OAKVILLE

Subject: Oakville Transit-Oriented Community (TOC)
Step 4 (i.e. Resubmission #1) Circulation Comments

- 1) 217-227 Cross Avenue & 571-595 Argus Road
- 2) 157 & 165 Cross Avenue
- 3) 166 South Service Road
- 4) 590 Argus Road

The Town of Oakville received the Step 4 (i.e. Resubmission #1) Oakville Transit-Oriented Community (TOC) Development Proposal from the Province, through Infrastructure Ontario on November 17, 2025. It was reviewed for completeness based on the materials submitted by Infrastructure Ontario and the Ministry of Infrastructure, as outlined in the *Oakville TOC Resubmission #1 Reference Guide*. It should be noted that while some of the submission materials were extensive documents for each location, others were updated items or grouped the locations into a single document. The file was promptly circulated to various internal and external staff and agency members to meet the Province's 60 day timeline for comments by January 30, 2026.

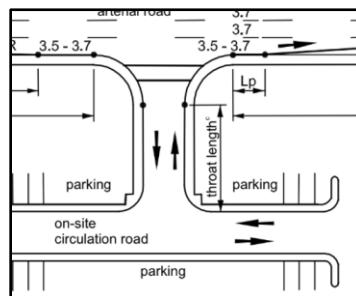
- d. [Circ. 2] – The interim design is not supportable due to:
 - lack of coordination and confirmation from MX,
 - Absence of traffic operational analysis,

- Reduction in through and eastbound left-turn lanes, and,
 - Duration of interim configuration is unknown.
- e. [Circ. 2] – MX driveway to the west is proposed to become a local road in the future. The Town does not support the one-way entry, one-way exit during the weekday a.m. and p.m. peaks, respectively. Such operation would require strict enforcements.

It is also unclear how “gate control” would enforce one-way reversible flow since the “gate” has to be open to allow entry or exit. If gate is located at or in close proximity to Cross Avenue, queue and spillback to Cross Avenue would be expected should a vehicle attempt an illegal maneuver. Furthermore, a U-turn would be required should an illegal attempt fail and the vehicle is stuck within the driveway.

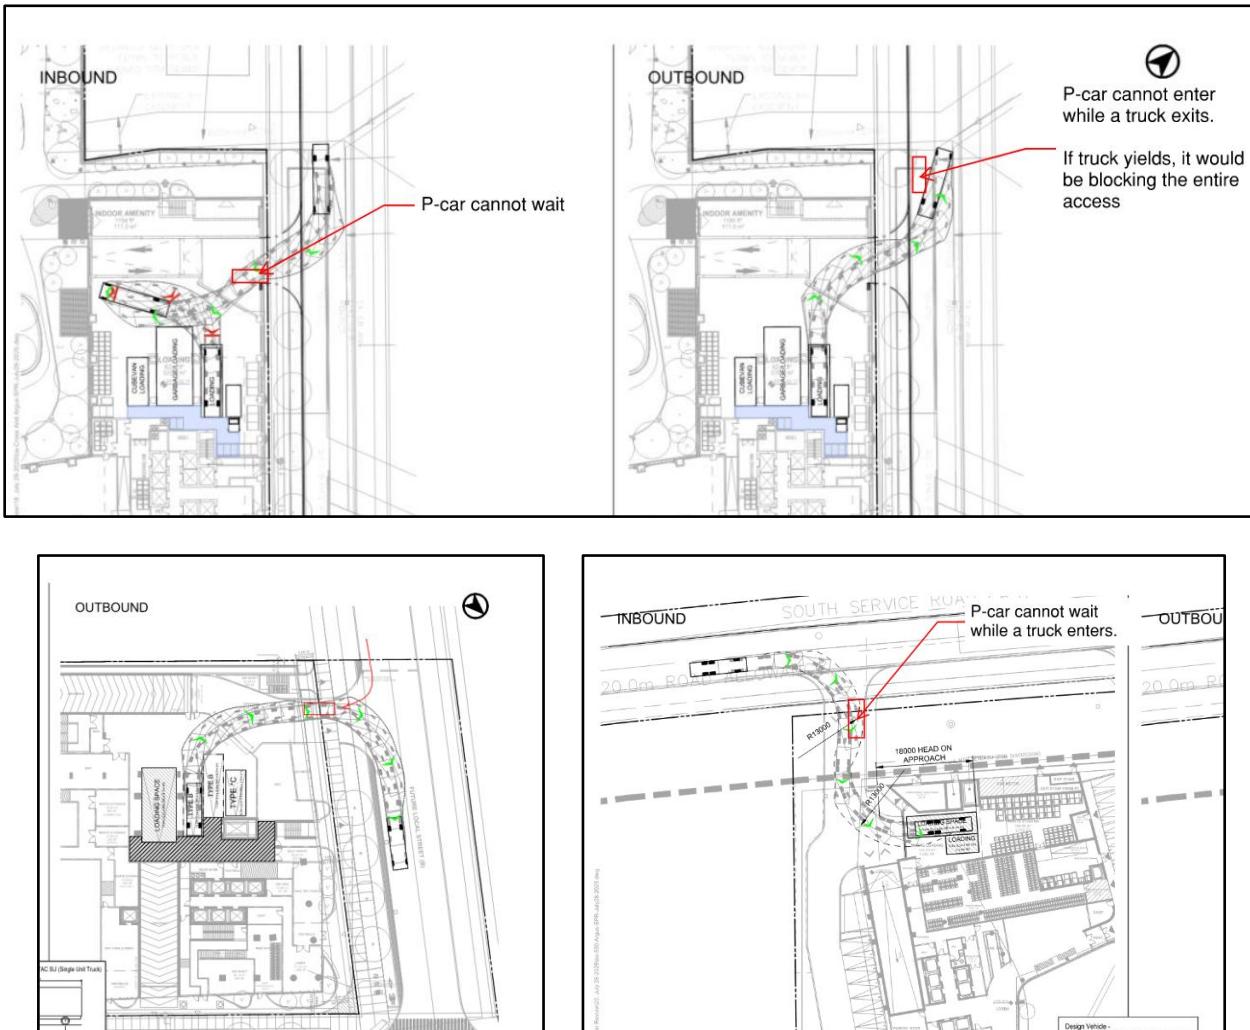
- a. [Circ. 2] – Two sets of Vehicle Turning Diagrams were submitted. New diagrams from July 2025 and revised diagrams from October 2023. The diagram numbers are duplicated. July 2025 Vehicle Turning Diagrams have poor resolutions. Staff cannot zoom in and review the drawings clearly.

Figure 1: Waste Storage Room of Tower A.

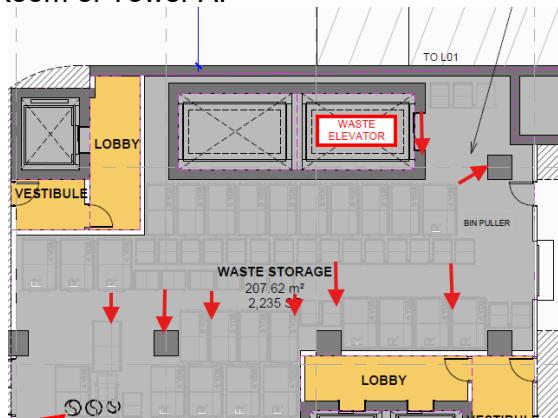
- Tower A:
 - Please show the distance between pillars, as well as cart spacing within the middle walkway. Please ensure that there is enough space to move bins to the elevator. See Figure 1

- Red arrows denote distances of concern regarding placement of waste receptacles and pillars.

Figure 1A: Waste Pathway to Loading area

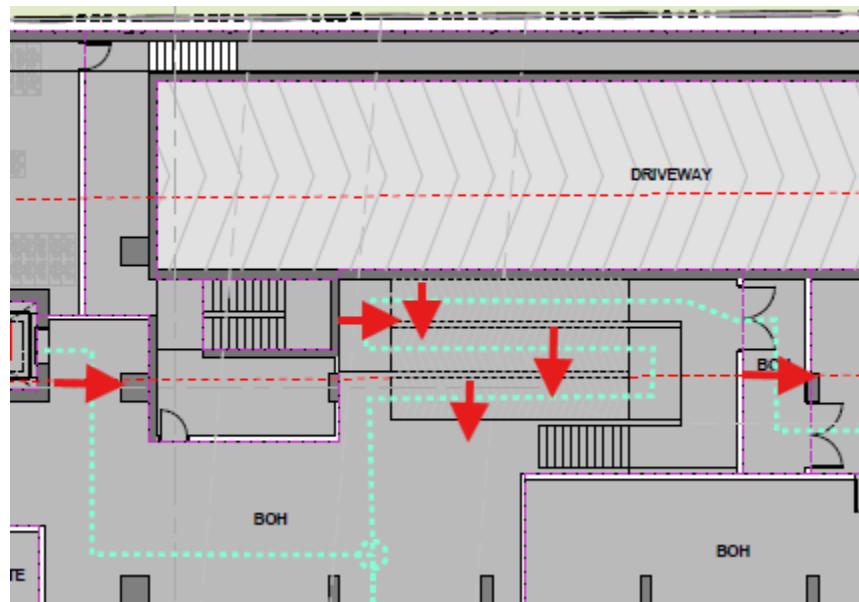
- Please indicate the dimensions of all waste elevators within the plan to ensure that waste receptacles can fit within the elevator.
 - Please indicate the width of the walkway to the loading area. See Figure 1A

- Red arrows denote distances of concern regarding

Figure 2: Image of Waste Loading Area

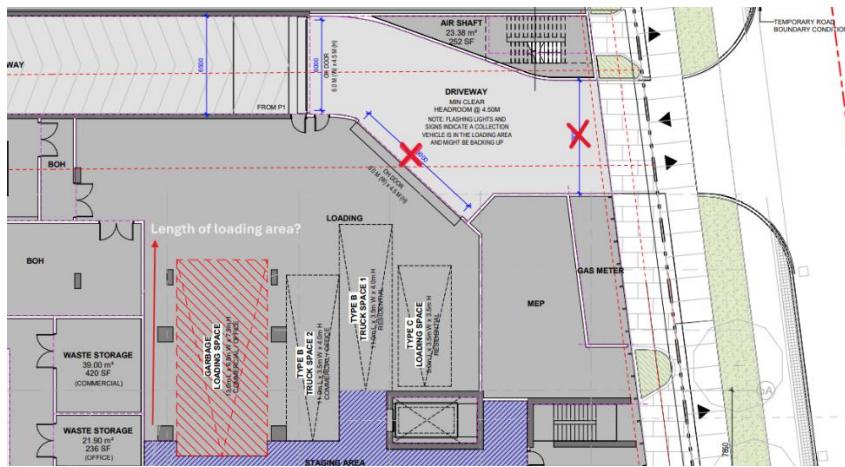
- Red "X" indicates where height should be indicated.
- Red arrow displays length needed for loading area

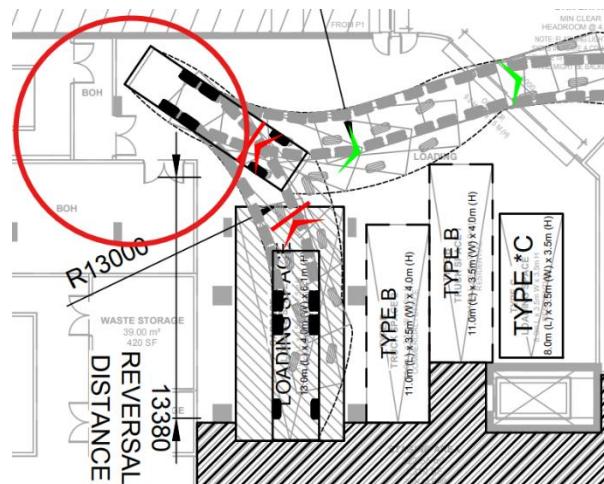
- Diagrams/Site Plans must show the following within the waste collection vehicles path:
 - Width of roads within the path of the collection truck (two way = 6 metres, one way = 4.5 metres)
 - Please indicate width of local road
 - Minimum head-on approach of 18 metres to the Collection Point. If entering an internal Waste Loading area, the waste collection vehicle should be entering it straight and not on a turn.
 - Currently vehicle enters on a turn.
- For Building A loading area, When vehicle reverses into two entry ways. To ensure the health and safety of staff, tenants, and residents, the path must avoid reversing into entry ways. Please indicate safety measures in place. See below for area of concern:

Figure 3: Chutes on Commercial/Office are on the Mezzanine

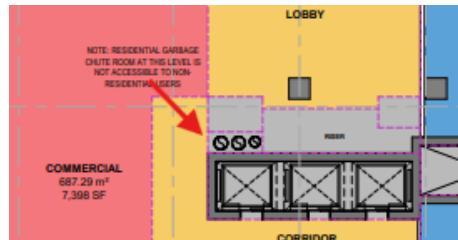
- Within Commercial/Office area on the mezzanine, please display walls for the chute area to ensure that non-residential users are not able to access (see figure 3). Should be similar to chute area near bike storage
- Please indicate what the Indoor Amenity will be on level 2 and level 3.
- On level 2 – why is one waste room accessible via door? How will the applicant ensure that waste room is not accessible to non-residents? (See figure 4)

- Red Arrow indicates chute area without any walls

Figure 1: Waste Room on Level 1

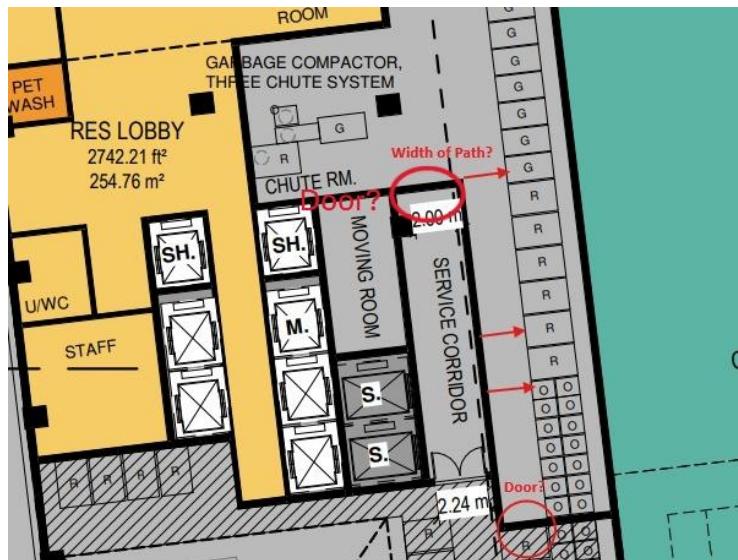
- Waste Movement
 - Within the plan, please display that the width of the pathway is included to accommodate for waste receptacles, as well as the dimensions of service elevators used. Ensure to clarify pathway of waste receptacles as it is not clear in the waste plan for Level P1 – can use arrows to determine path.
 - For the waste storage room on level 1, access to the waste loading area may be impeded by placement of waste receptacles. There are also no doors to access the room. Please include width of waste receptacle path, as well as drawings of doors.

- Red circles denote areas with possible doors
- Red arrows denote areas where width needs to be indicated.
 - For Garbage Room #2, please indicate width of waste receptacle movement path. Region is concerned with spacing between parking spaces/cars and wall. Also – if service elevators will be used, please indicate size of service elevators to ensure that they can accommodate waste receptacles. See figure 2.

Figure 2: Garbage Room #2 and Waste Movement Path

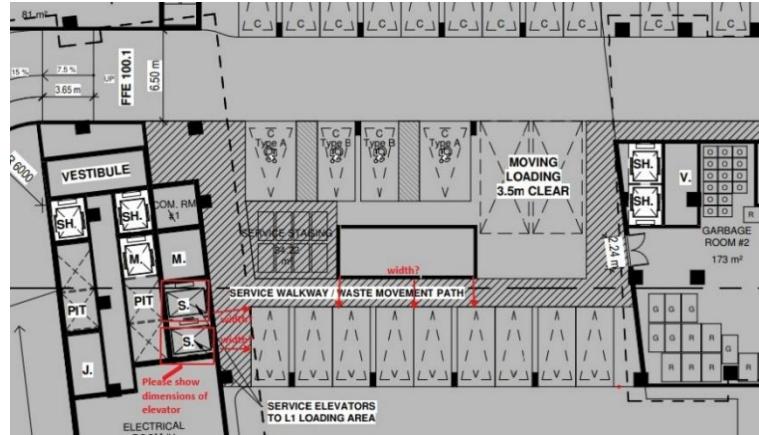
- Red arrows denote areas where width needs to be indicated.
- Red squares indicate areas where dimensions of elevator need to be indicated.
 - For Garbage Room 3 – please confirm the waste path. Not clear within plan – See figure 3 for possible waste pathway

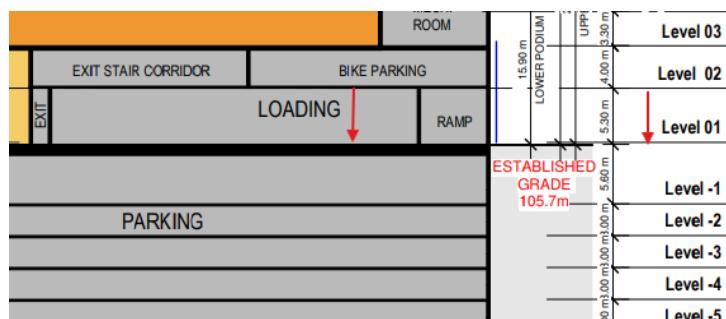
- The Waste Loading area must be minimum 7.5 m high x 6 m wide x 18 m long to ensure the Waste collection vehicle can fully enter the Indoor loading are and ensure the minimum approach requirement is met.
 - Currently length of loading area is 13 metres
 - Within Elevation drawings – entire loading area is shown to 5.3 metres. Should be 7.5 metres throughout to avoid any potential collisions with the roof of the loading area. See below:

Figure 5: Waste Vehicle Exiting Loading Area

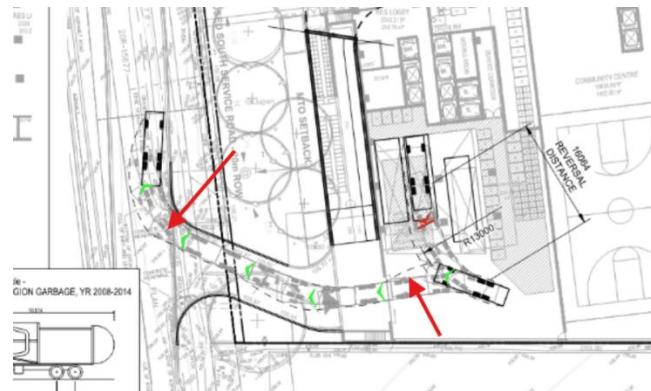
- Circle denotes area of concern
- Please indicate the turning radius of the waste vehicle exiting the loading area, as noted in Figure 5 below.

- Arrows denote missing turning radius

Figure 1: Garbage Room C on Parking Level 1

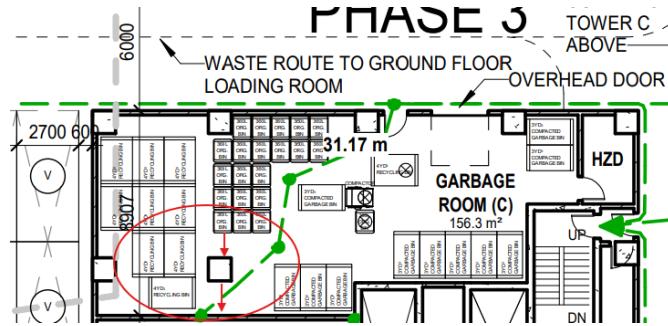
- For Garbage Room C, the Region is concerned regarding the spacing of the bins to the pillars. Please ensure that each bin is accessible for use and move to the chutes/outside of storage room. Please see figure 1:

- Circle denotes area of concern
- Arrow denotes widths needed to confirm safe movement of bins
- Waste Capacity:
 - Number of waste receptacles needs to increase to accommodate capacity for residential units. See below for calculations:

Figure 2: Tower A Waste Loading Area

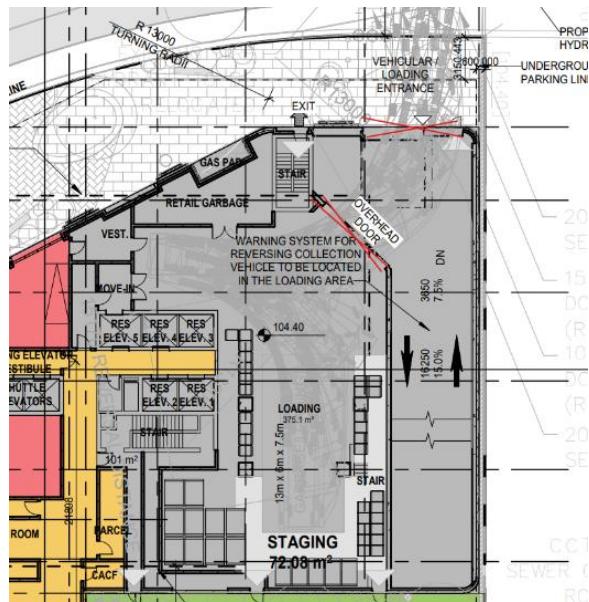
- Red "X" denote entrance areas which need dimensions
- Tower C:
 - The Waste Loading area must be minimum 7.5 m high x 6 m wide x 18 m long to ensure the Waste collection vehicle can fully enter the Indoor loading are and ensure the minimum straight head on approach requirement is met.
 - Currently length of loading area is 13 metres
 - Please show waste loading area height with elevation drawings
 - Please indicate the height and width of entrance doors to loading area – see figure 3.
 - 5m clearance
 - 6m in width
 - Please show and label all bins for a day of collection in the staging area
 - For once a week collection, please show the following in the staging area:
 - 40 Organics carts
 - 16 Recycling bins
 - 18 Garbage bins
 - For twice a week collection, please show the following in the staging area:
 - 20 Organics carts

Figure 3: Waste Loading Area in Tower C

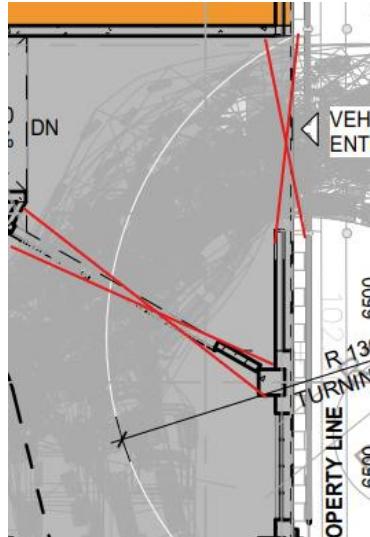
- Red "X" denote entrance areas which need dimensions

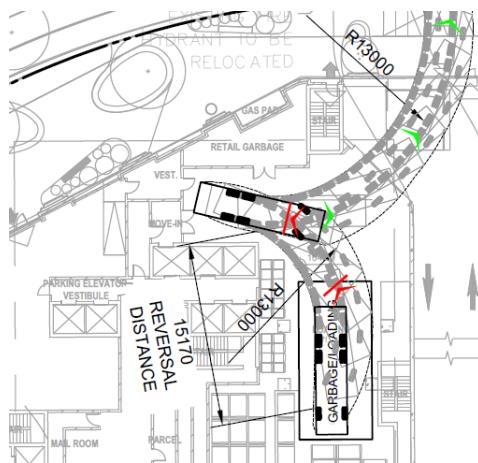
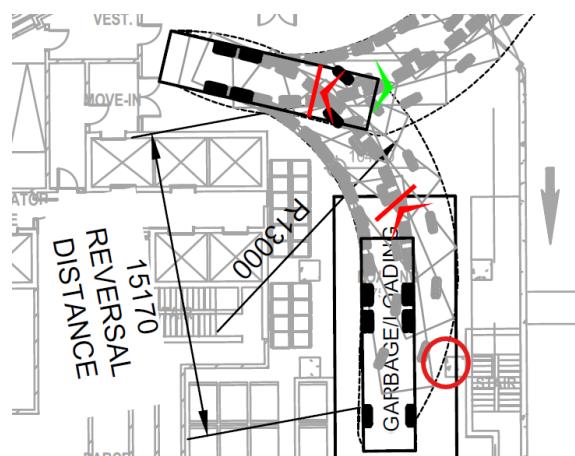
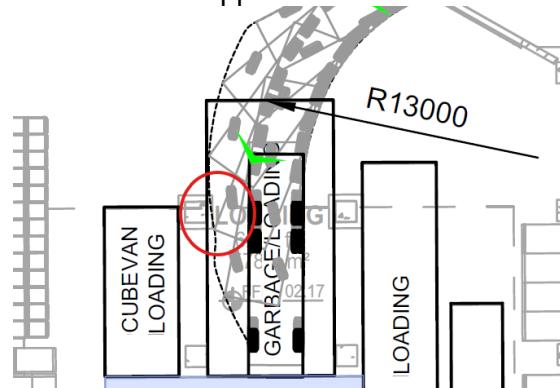
- Diagrams/Site Plans must show the following within the waste collection vehicles path:
 - Width of roads within the path of the collection truck (two way = 6 metres, one way = 4.5 metres)
 - Minimum straight head-on approach of 18 metres to the Collection Point.
 - Current head approach is not straight
- For Building A loading area, When vehicle reverses into two entry ways. To ensure the health and safety of staff, tenants, and residents, the path must avoid reversing into entry ways. Please indicate safety measures in place. See below for area of concern:

- For both Building A and Building C Loading area, Waste vehicle path interferes with pillars – please show an alternate approach. See areas circled below:

Figure 5: Example of Waste room without chutes

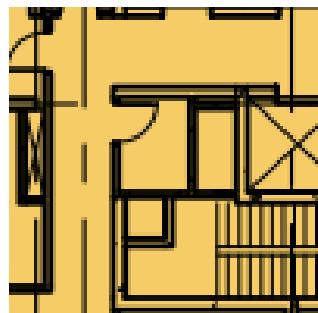
- Some waste rooms do not display the 3 separate chutes. Please include within drawings

Figure 1: Service Elevator Located within Tower A.

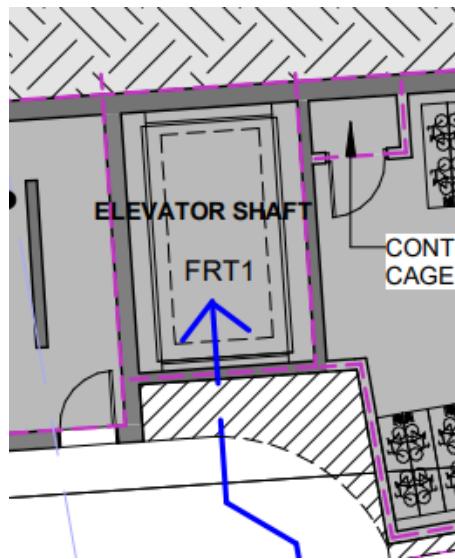
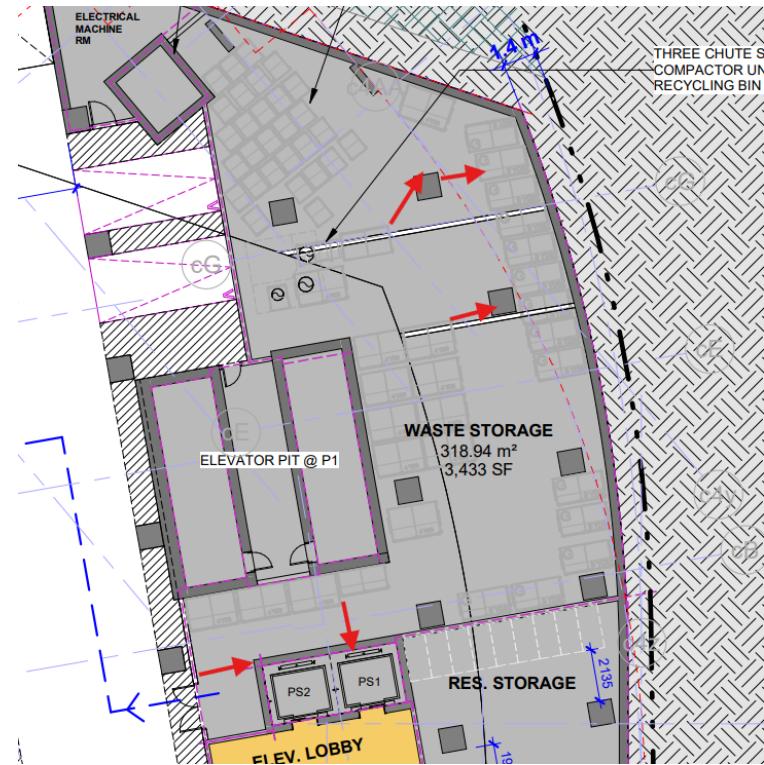
- Waste Receptacles Capacity
 - Please show all bins within each storage room - Tower A waste storage currently does not include all bins.
- Waste Movement
 - Please show dimensions of all service elevators being used to move waste receptacles to determine if waste receptacles can fit. See Figure 1

Figure 2: Tower C Waste Room

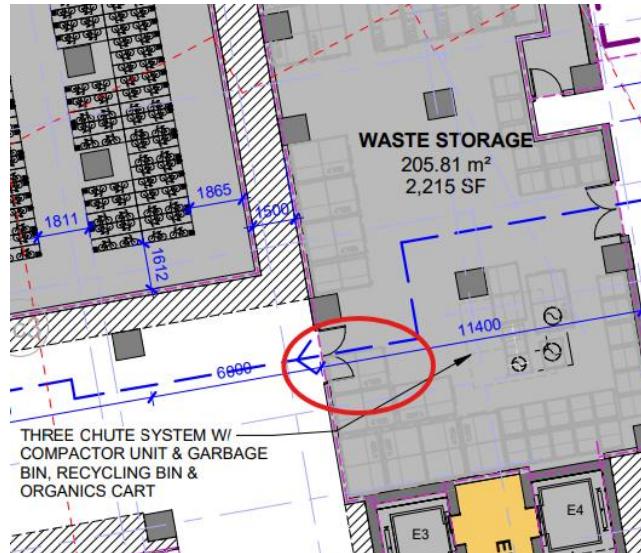
- Please show equipment being used to move waste receptacles within the storage areas in the plan – not clear what equipment will be used for residential use.
- For Tower C waste room, please show the distance between pillars, as well as cart spacing within the middle walkway. Please ensure that there is enough space to move bins to the doorway. See Figure 2
- For Tower B Waste Room, access doors do not fully open as there is a bin blocking one side. Please reconfigure the bins accordingly – see Figure 3.
 - Tower B waste storage currently shows recycling bin within a pillar – please rearrange:

- Red arrows denote distances of concern regarding placement of waste receptacles and pillars.

Figure 4: Display Additional Waste Storage on Level 1

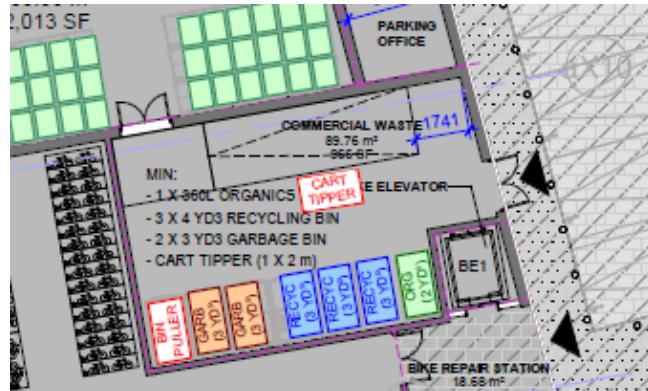
- Circle denotes area of concern
- Near waste staging area, there is a separate room with commercial waste storage and additional bins/carts. Please confirm if the room would only be used for commercial waste – should be stored separately from residential waste. See figure 4.

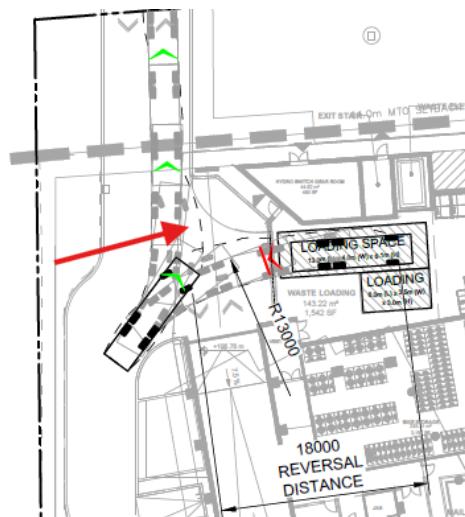
- Diagrams must show the following within the waste collection vehicles path:
 - Width of roads within the path of the collection truck (two way = 6 metres, one way = 4.5 metres)
 - Please indicate width of local road
 - Minimum head-on approach of 18 metres to the Collection Point. If entering an internal Waste Loading area, the waste collection vehicle should be entering it straight and not on a turn.
 - Currently vehicle is entering on a turn
 - Turning radius of 13.0 metres from the centreline. Indicate all turning radii along vehicle path – see below for missing radius:

Figure 5: Waste Room on Tower B

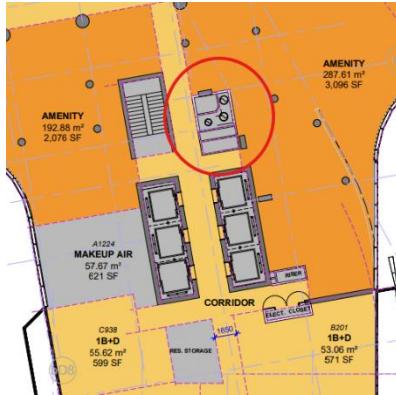
- Will the community space be private? Or through Town of Oakville?
- Please identify what the amenities outlined in orange will be, and if they will be accessible to residents only.
- Waste Room in Tower B and C does not have doors. Please ensure that the waste room is accessible to only residents of the building. See Figure 5.

- Note: Please ensure that the office space will not have access to the waste room
